MeshSat field kit V2, Option A(i) lid pack: sheet A1-1 arrangement B in plan: the lid module, the QMX set and every face part under the lid

MESH SAT-1357, stream a1mech, 29 Sep 2026. Case frame: X east, Y toward the hinge (back) wall, Z up from the base floor, lid closed. mm. Prototype design, AI review: nothing built, bought or fitted; analytical success is not physical verification.

MeshSat field kit V2, Option A(i) lid pack: sheet A1-3 the arrangements that fit, and the owner decision

MeshSat field kit V2, Option A(i) lid pack: sheet A1-4 the hinge harness: route, travel, ties, disconnect; the QMX DC lead re-routed

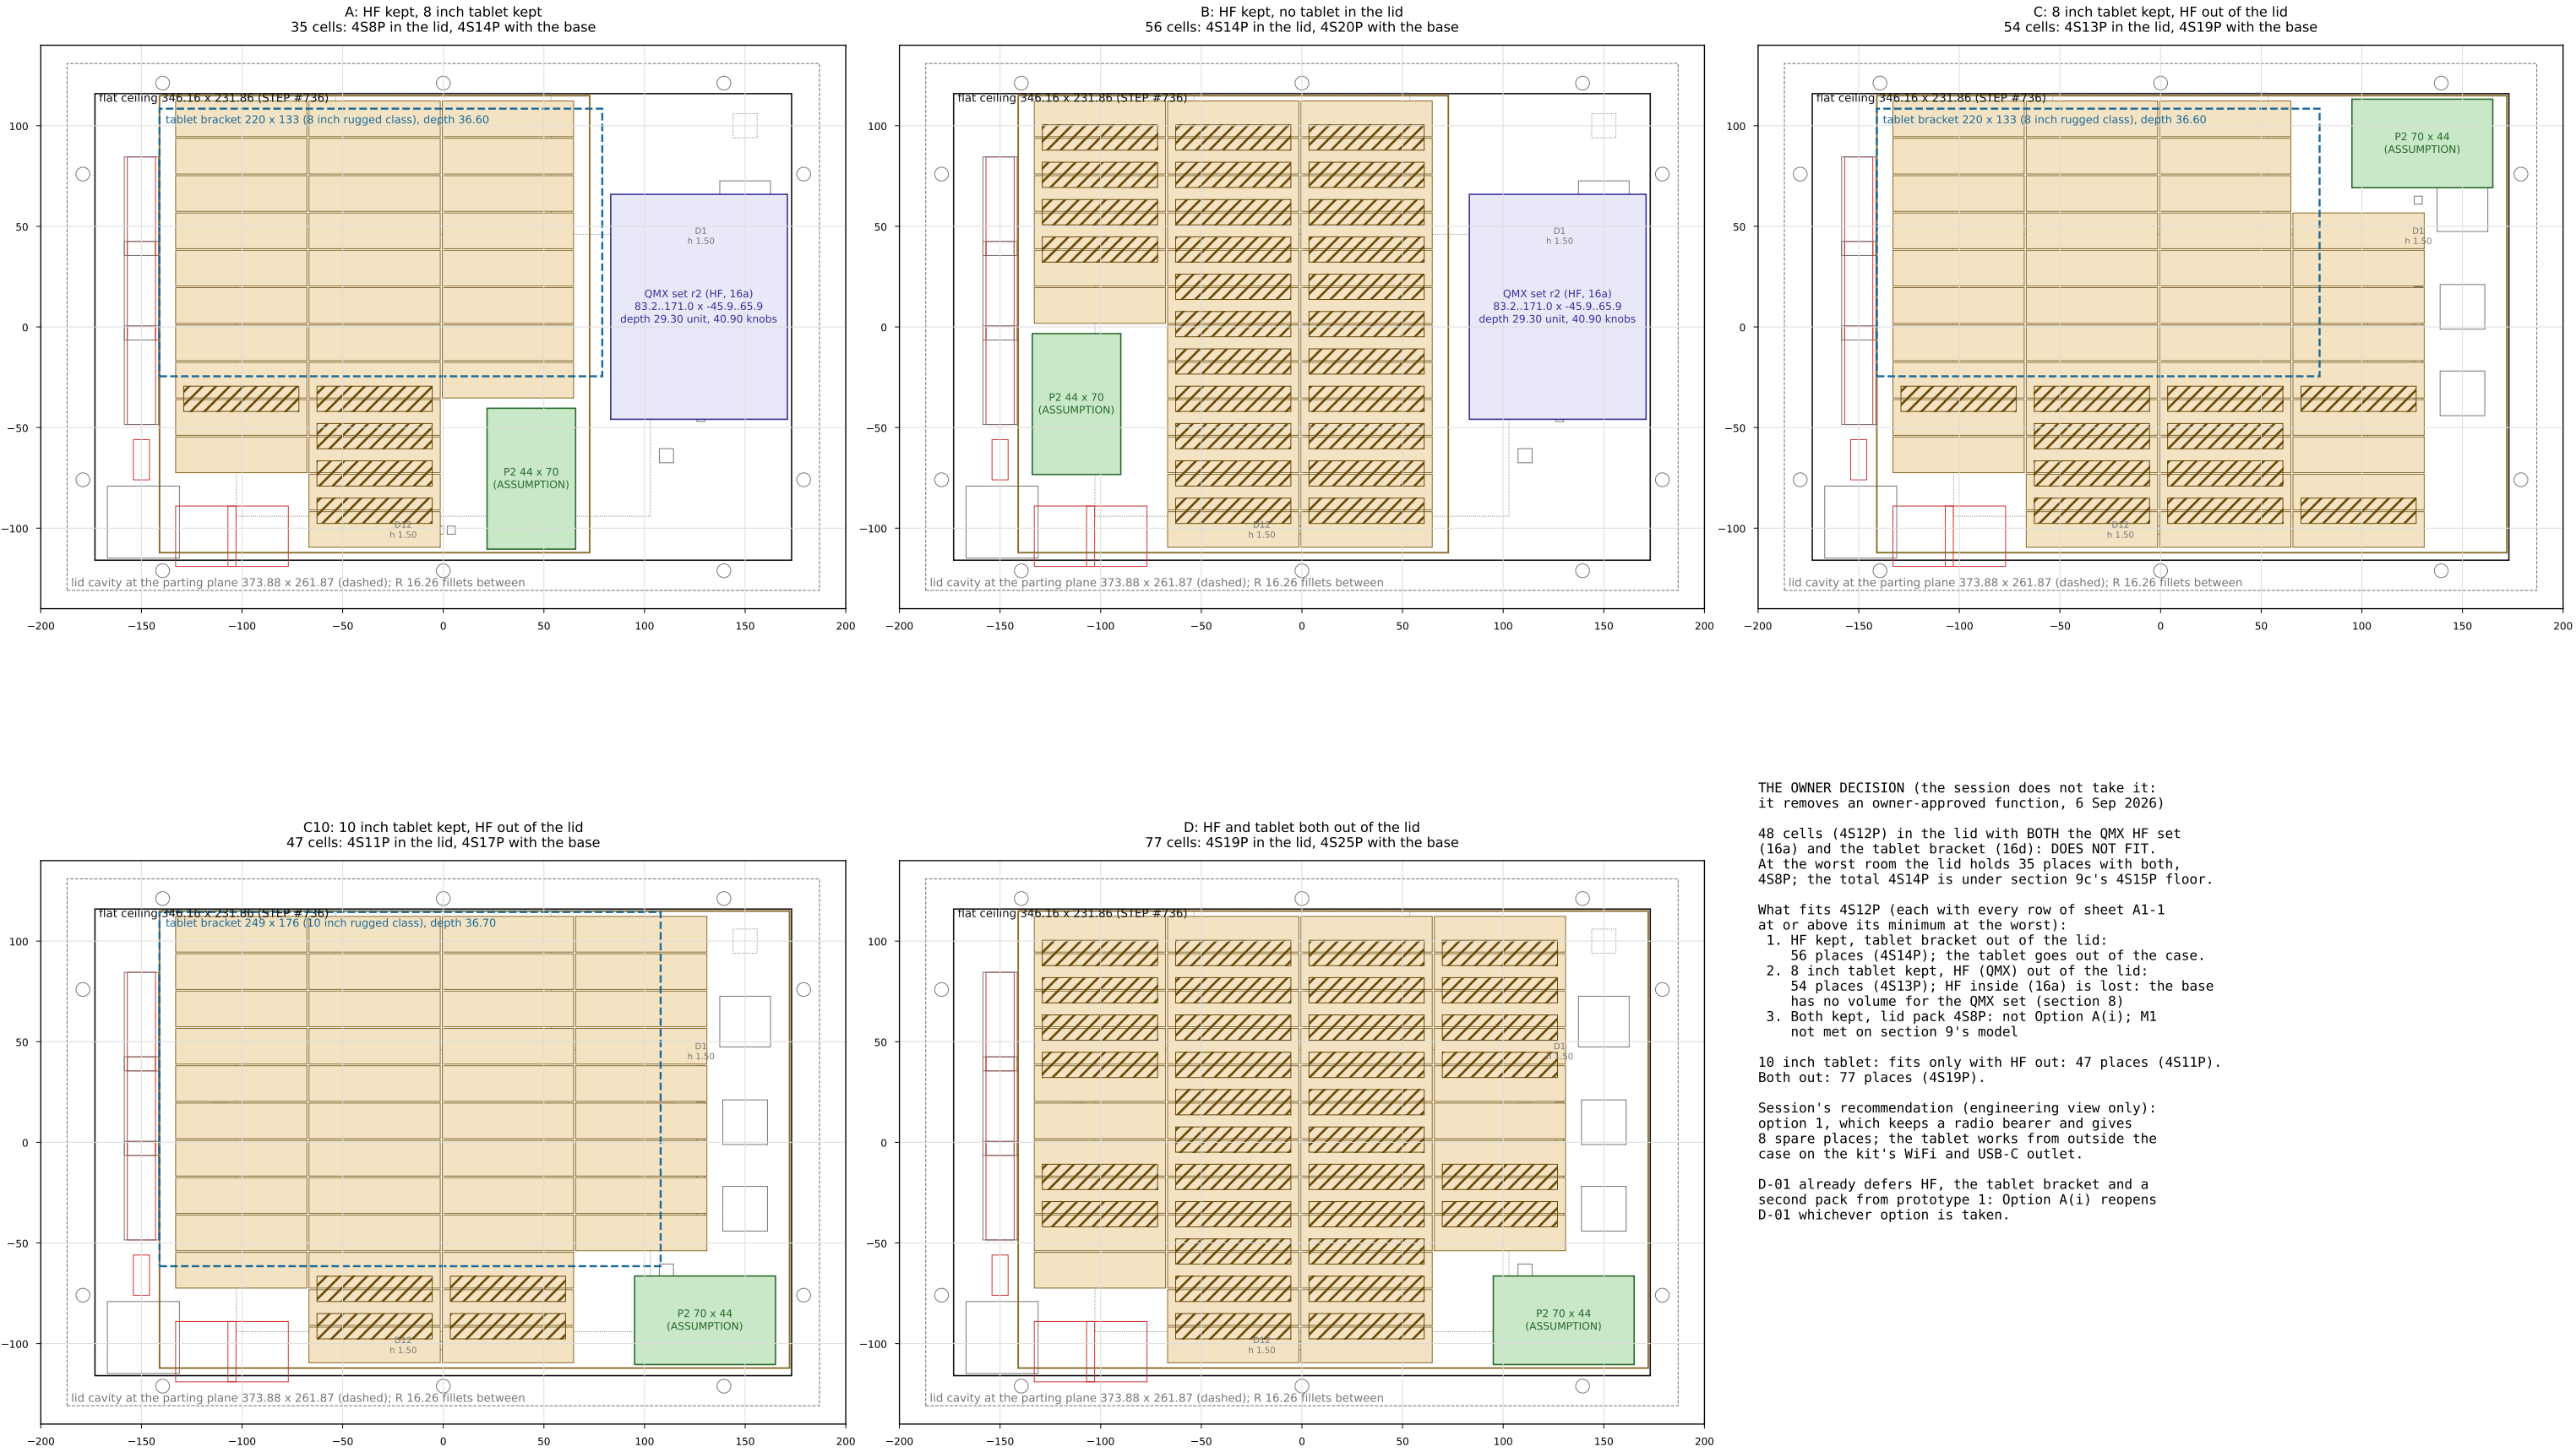
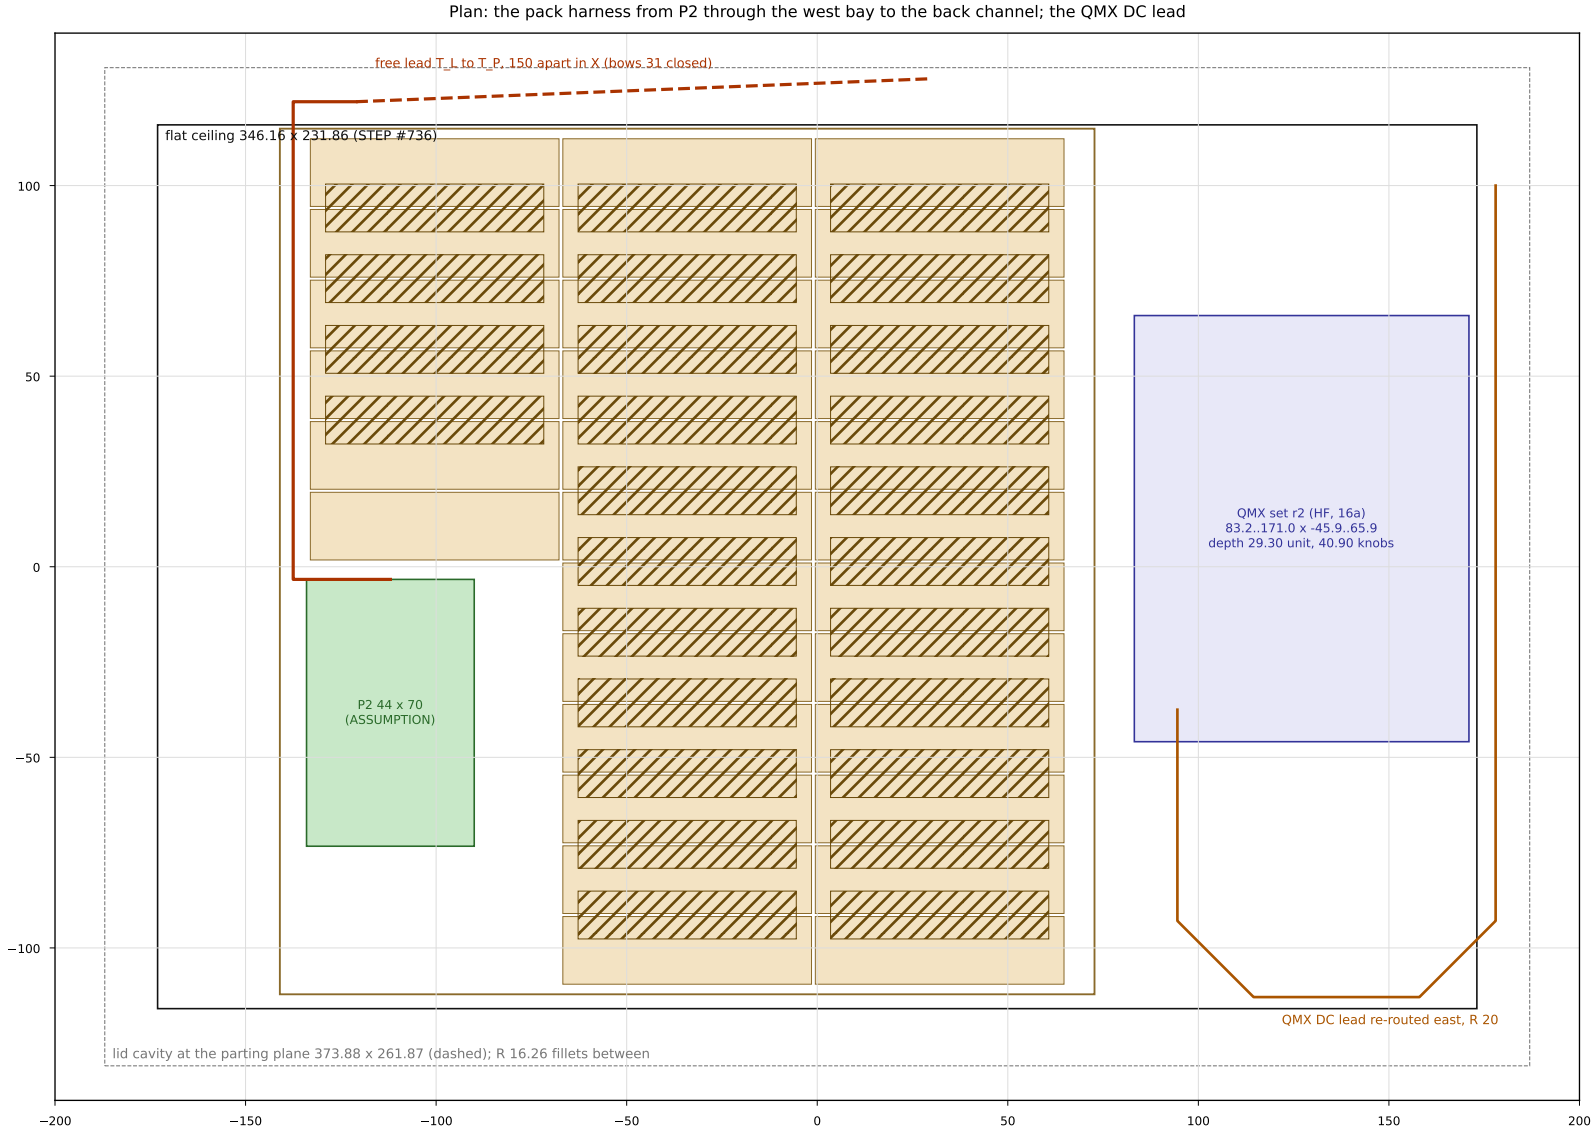
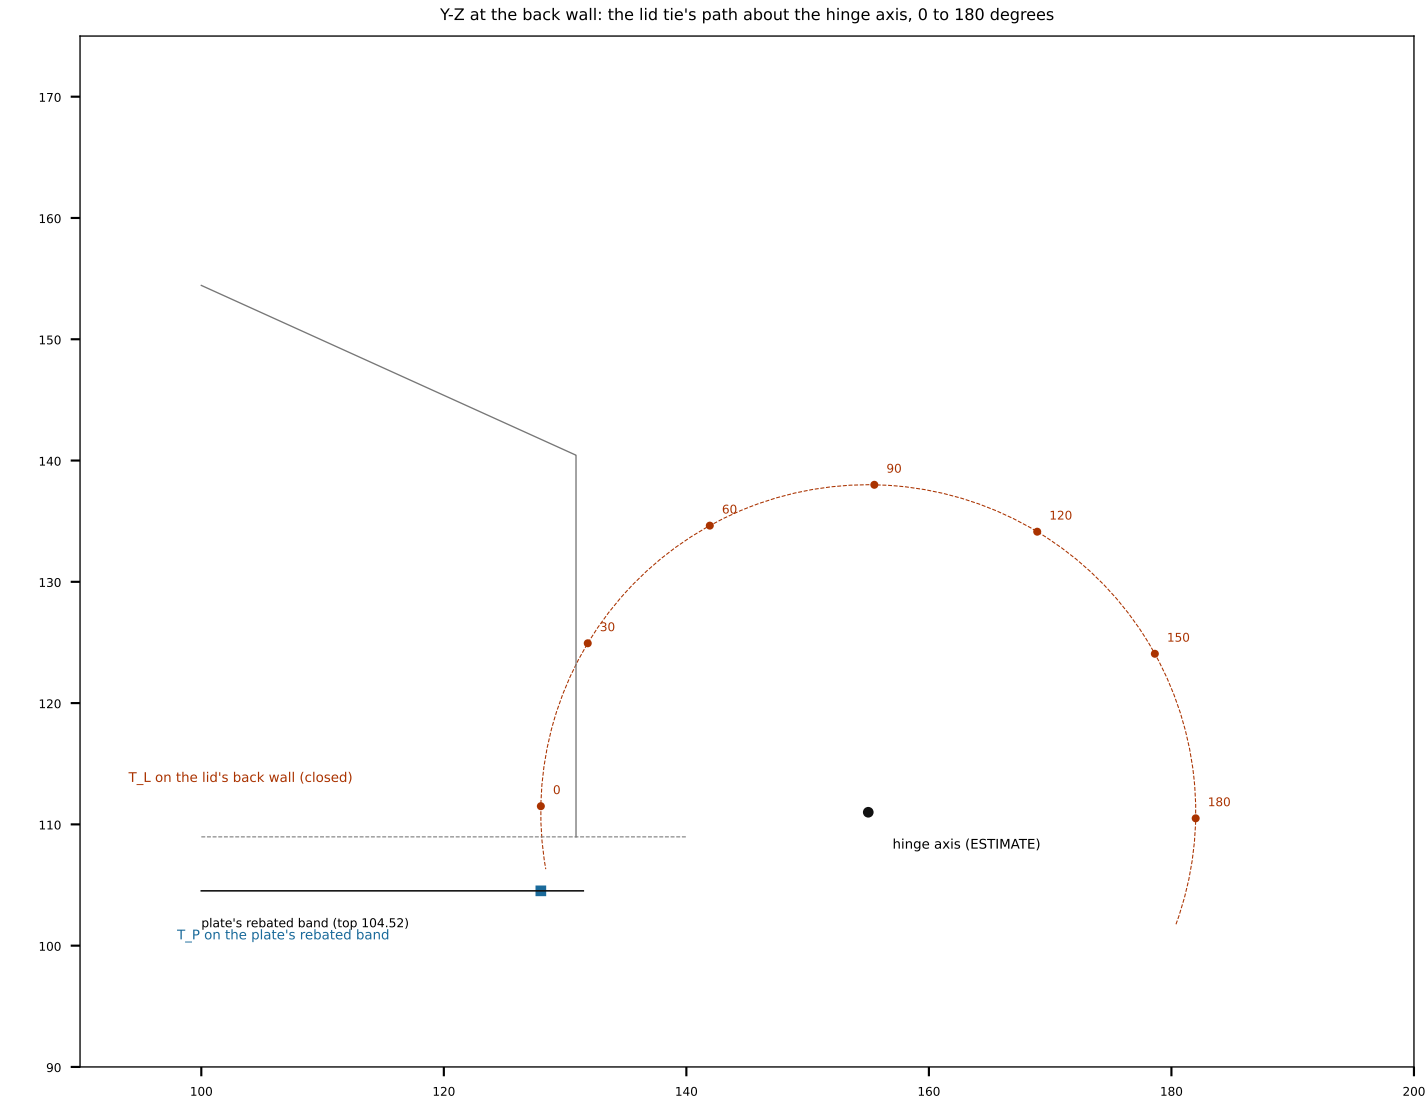
48 cells (4S12P) in the lid with BOTH the QMX HF set (16a) and the tablet bracket (16d): DOES NOT FIT.
At the worst room the lid holds 35 places with both, 4S8P; the total 4S14P is under section 9c's 4S15P floor.

1. HF kept, tablet bracket out of the lid:
56 places (4S14P); the tablet goes out of the case.
2. 8 inch tablet kept, HF (QMX) out of the lid:
54 places (4S13P); HF inside (16a) is lost: the base has no volume for the QMX set (section 8)
3. Both kept, lid pack 4S8P: not Option A(i); M1 not met on section 9's model

10 inch tablet: fits only with HF out: 47 places (4S11P). Both out: 77 places (4S19P).

Session's recommendation (engineering view only): option 1, which keeps a radio bearer and gives 8 spare places; the tablet works from outside the case on the kit's WiFi and USB-C outlet.

MeshSat field kit V2, Option A(i) lid pack: sheet A1-5 mass and open-lid stability

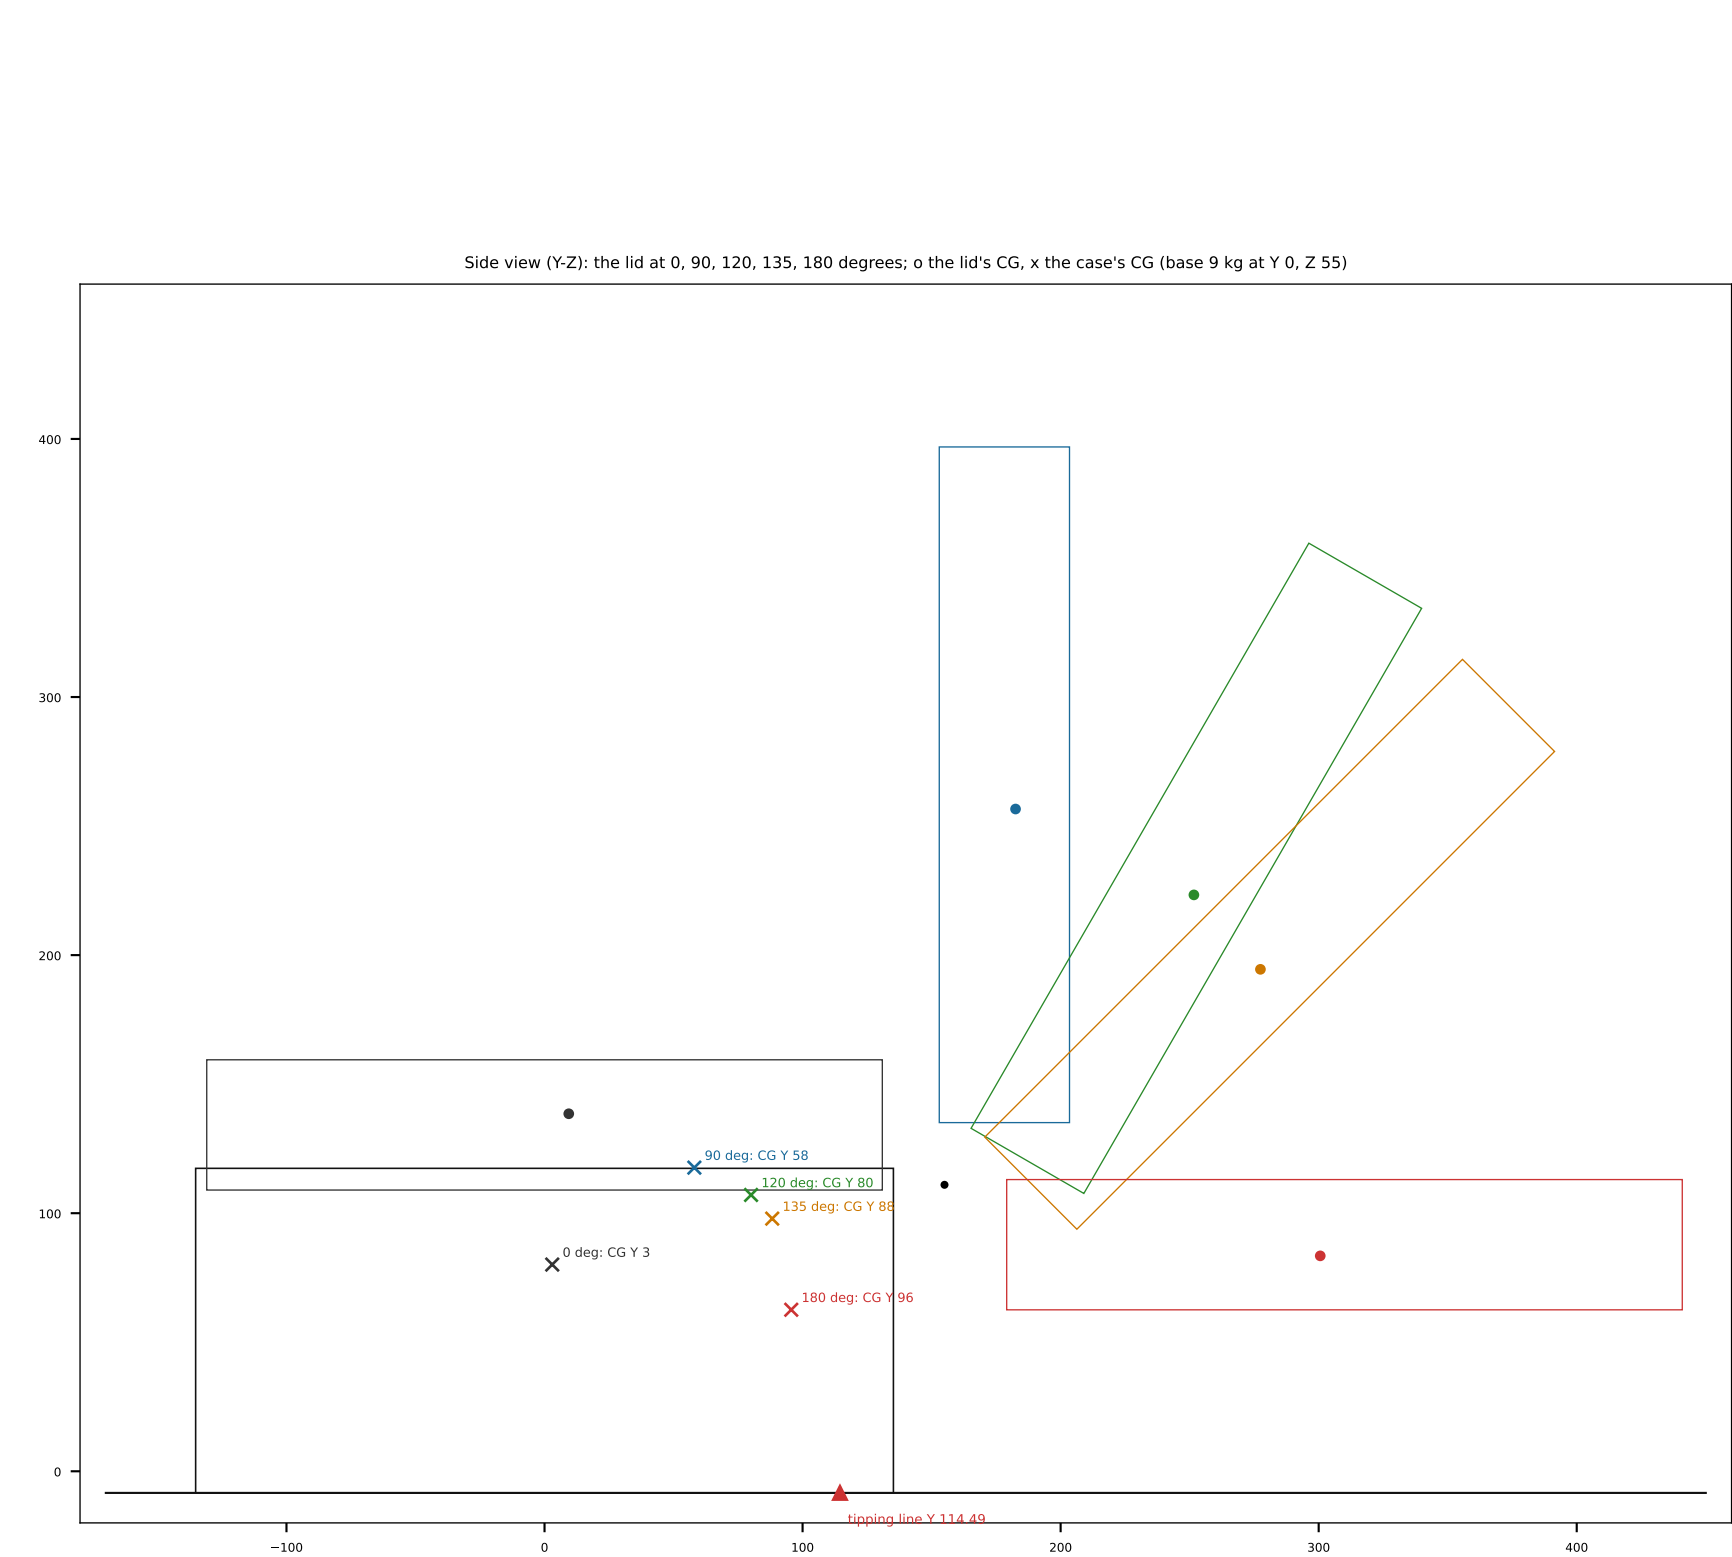
WORST OVER THE SWEEP (base 7..14 kg, CG Y -20..+20, Z 45..65, hinge axis Y 147..163): critical back slope, deg

lid open	B	A
90	14.9	17.1
100	11.6	14.0
110	8.4	11.1
120	5.4	8.4
135	1.3	4.9
150	-2.2	2.2 (tips on level ground)
180	-5.0	1.7 (tips on level ground)

VERDICT: stands on level ground to 120 degrees of opening in every swept case; a light base tips from 135. FIX (SESSION, reversible): a lid stay stopping the lid at 100 degrees (webbing strap between two bonded anchors, lid wall and frame skirt; no hole; about EUR 10, ESTIMATE). With it the open case stands on a back slope of about 10 degrees at the worst (lid_pack a1.out section 4). The stop angle, the hinge axis and the case's CG are read on the mock-up (T-A1-3); Peli states no load for its hinges (T-A1-4).
